Borough of Rumson
BOROUGH HALL
80 East River Road
Rumson, New Jersey 07760-1689
rumsonnj.gov

Denial Memorandum

Applicant: Stephen & Nadia Harhen / Robert W. Adler & Assoc.

Address: 9 Circle Drive, Rumson, NJ 07760
Block 13, Lot 15, Zone: R-3

DRAWING:
COVERPAGE

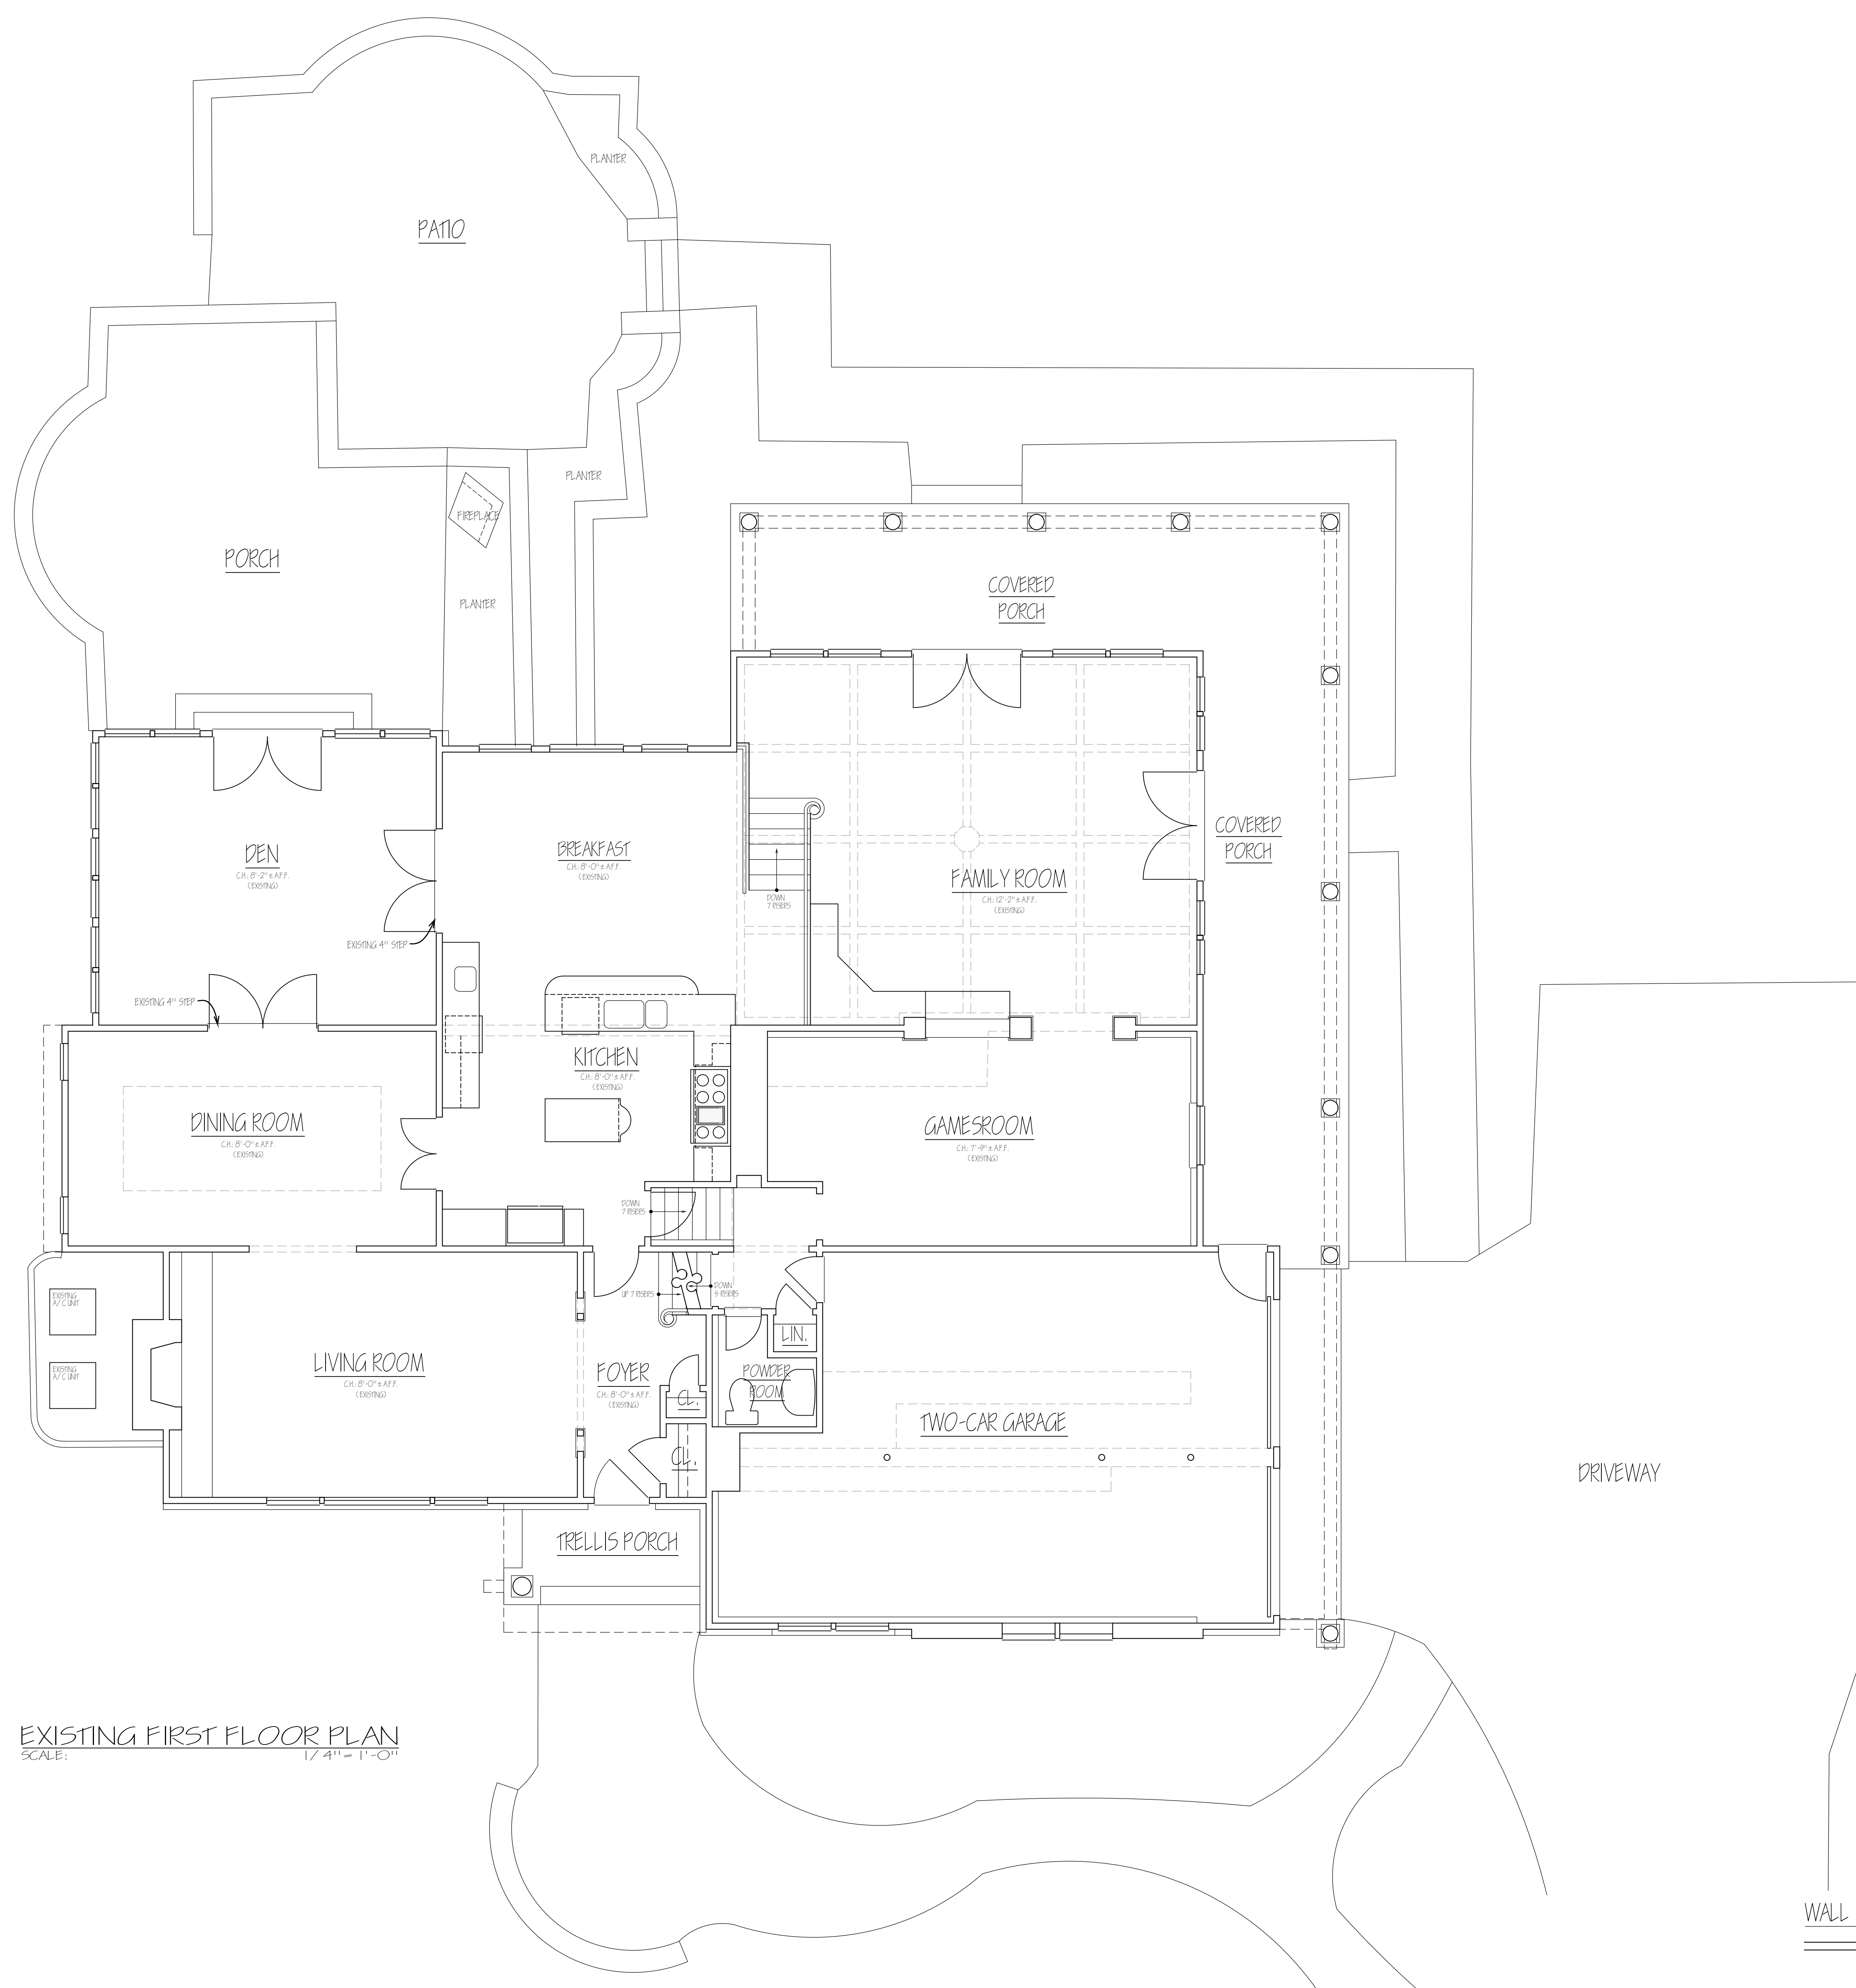
- A proposed Site Plan was not included with the application.
6. Zoning Chart Information requiring correction:
 - Required side yard setbacks of 22' / 42'

- Label of Proposed Calculations, sheet1 of 8
